From: [Pat Potter](#)
To: [City Clerk](#)
Subject: [EXTERNAL] City Council Agenda Item 7-B 6-21-22
Date: Wednesday, June 22, 2022 6:13:27 AM

I would like to submit my public comment regarding agenda item 7-B in the city council meeting tonight (June 21st) regarding the Grand Street Resurfacing and Safety Improvement Project. I support the actions supported by staff and the transportation commission.

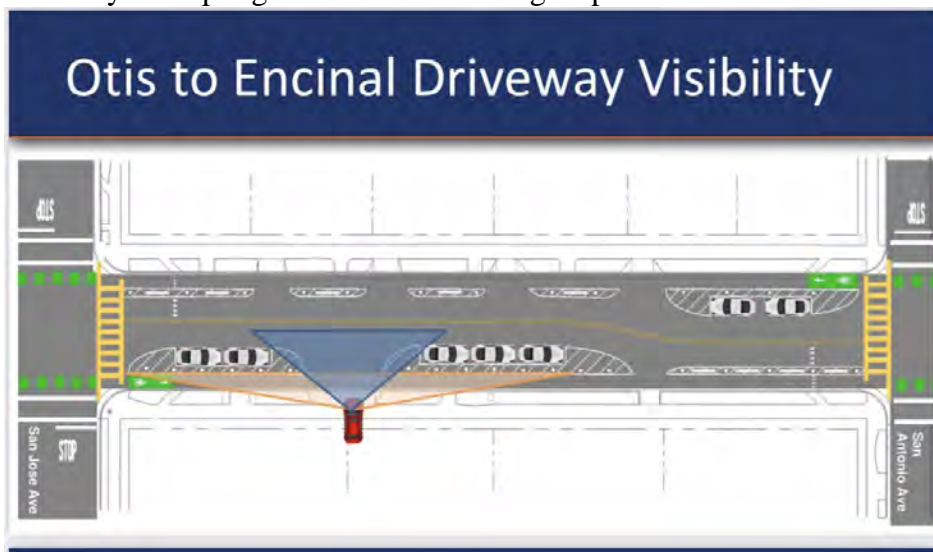
The project consultants' design plan is flawed. The idea for delivery vehicles is to block driveways. Unfortunately the plan shows a double width driveway. In reality most homes on Grand Street have only a narrow single car width tandem driveway. I only counted two double width driveways from Encinal to the lagoon bridge. Even so only a small delivery truck would fit this space. They also show delivery trucks can park in the spots but by reducing street parking I fear these spots won't be available. Furniture, landscape supplies, large UPS trucks, utility trucks would be forced to double park blocking the road. These larger deliveries take longer to unload and it won't be just for a couple of minutes. This will cause traffic congestion and danger when cars are going around in opposite lane.

The plan for driveway visibility is similarly flawed. Again it shows a double car width driveway with a car pulling forward onto the street. The reality, single car width with cars backing out of driveways. The rendering shows the cars pulling out with no parked cars on the other side but if you notice the opposite side of the street the driveways have cars parked across from them. When you do back out of the driveway I'm afraid you will have difficulty clearing a narrow radius when the parked cars are in the middle of the street. I already have difficulty attempting this with a much larger space.
